**ADDENDUM  
NO. 3**

**Alexandria Athletic Field Improvements  
1 Burden Court  
Alexandria, IN 46001**

## ADDENDUM THREE

**Addendum Three (AD.03)** to the drawings and specifications prepared by Gibraltar Design for **Alexandria Elementary School Athletic Field Improvements** for Alexandria Community School Corporation, Alexandria, Indiana.

GIBRALTAR DESIGN SHEET  
**C-201**

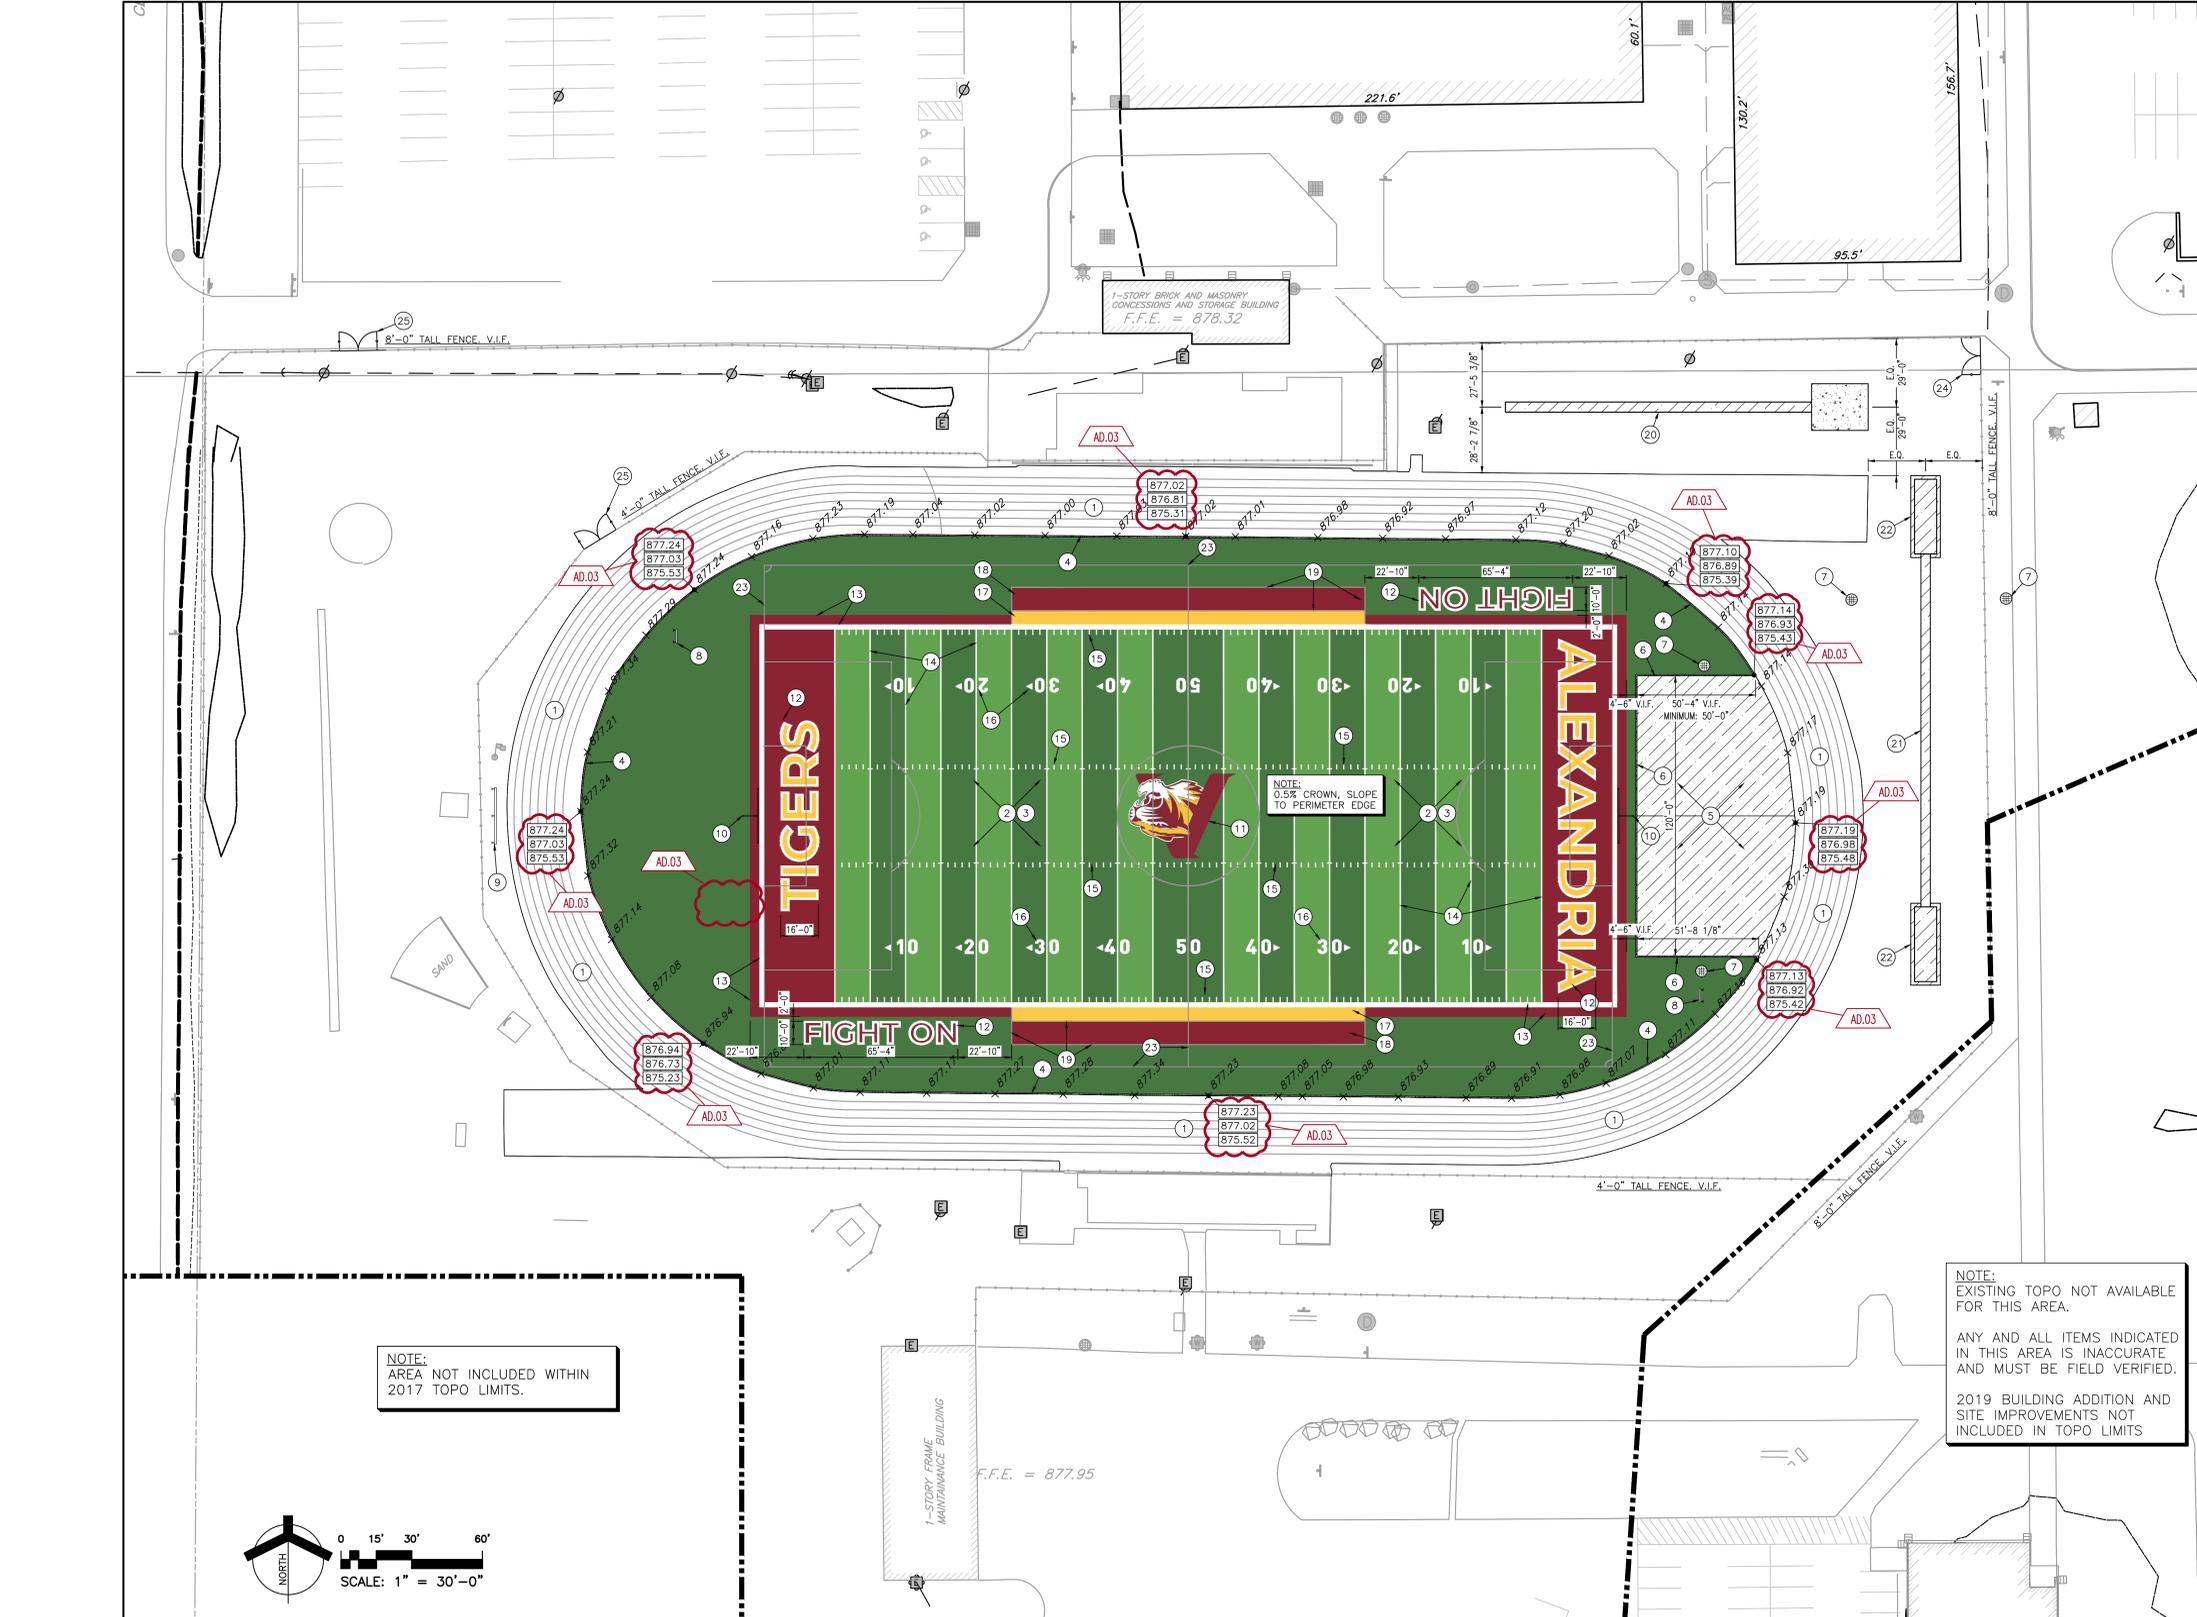
**DRAWINGS****5. Sheet C-201**

- A. Refer to revised, full-size drawing, included in this Addendum, for revisions.
  - 1. Remove floating note #10.
  - 2. Revised approximate top of stone and top of subgrade elevations.

SHEET  
**C-202**

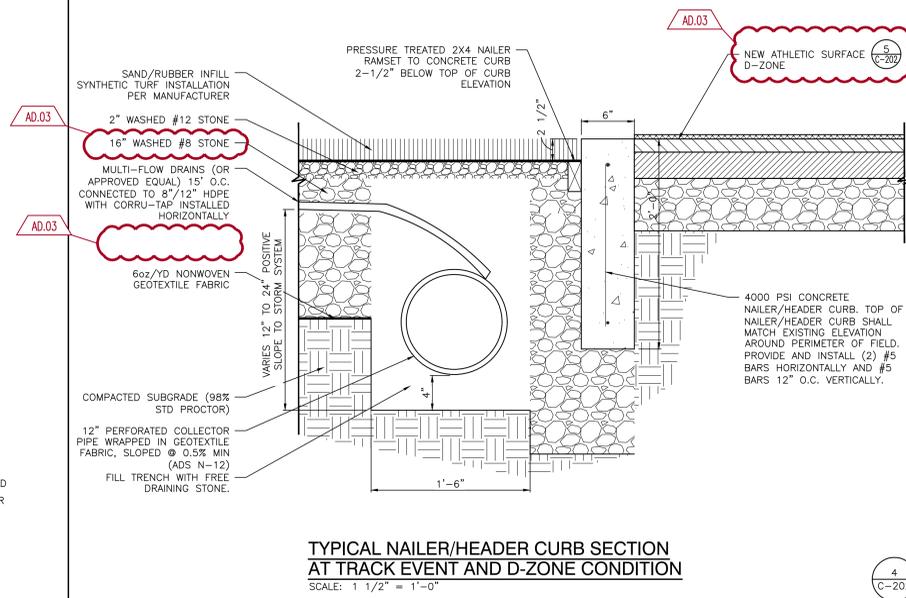
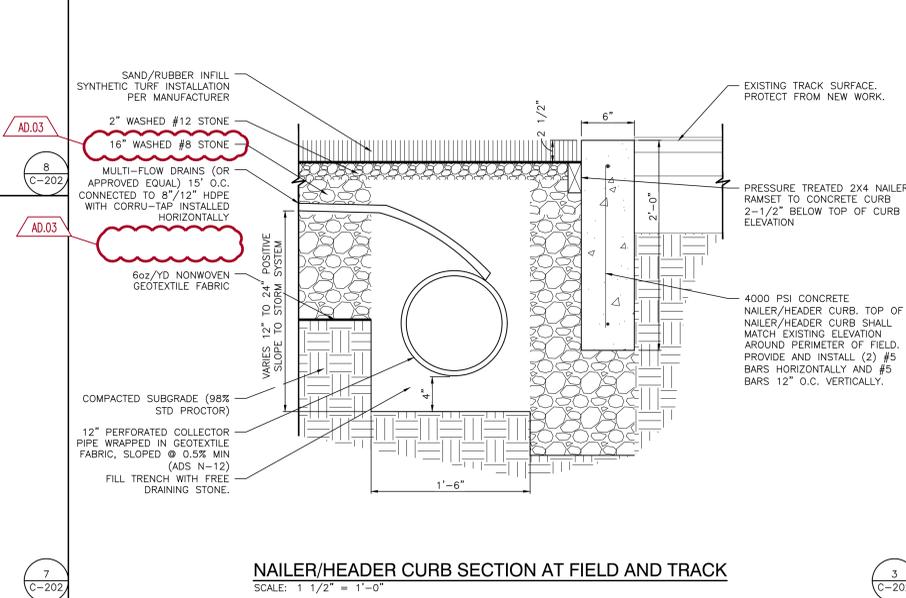
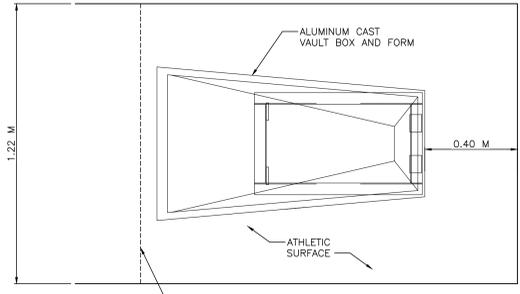
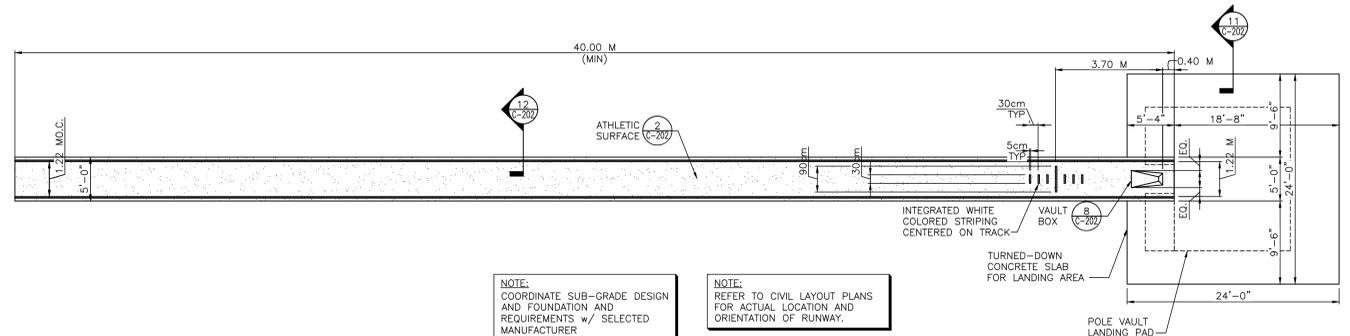
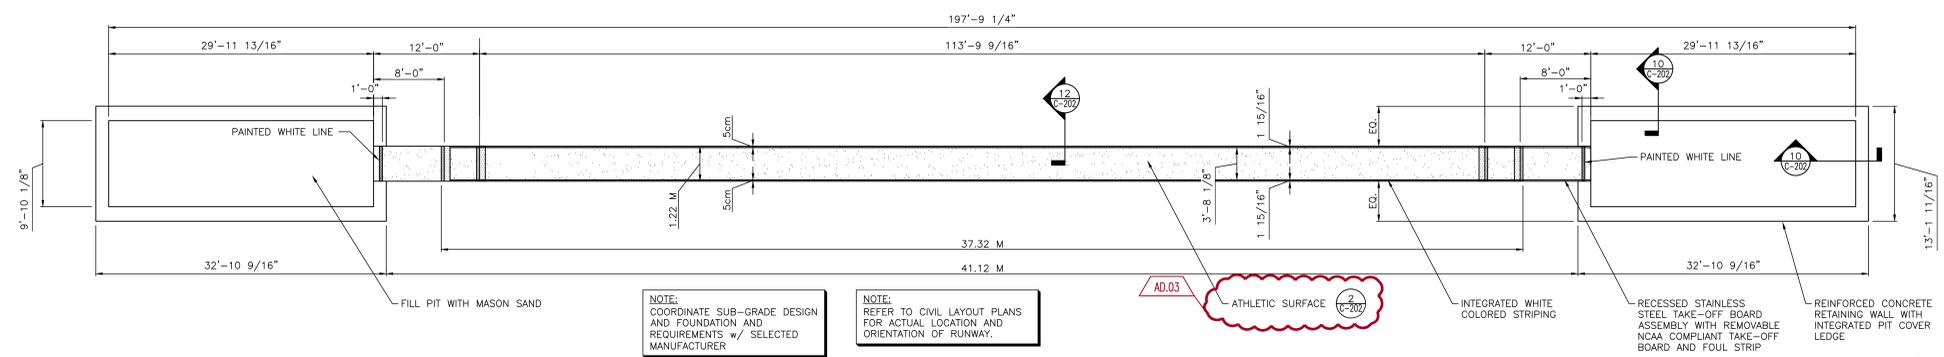
**6. Sheet C-202**

- A. Refer to revised, full-size drawing, included in this Addendum, for revisions.
  - 1. Clarification to detail tag callouts.
  - 2. Clarification to stone type and depth of stone.
  - 3. Clarification: Request for substitution of concrete slab in lieu of the asphalt surface for the D-Zone – is acceptable provided elevations and alignment to the existing track is maintained and exterior concrete reinforcing is provided.
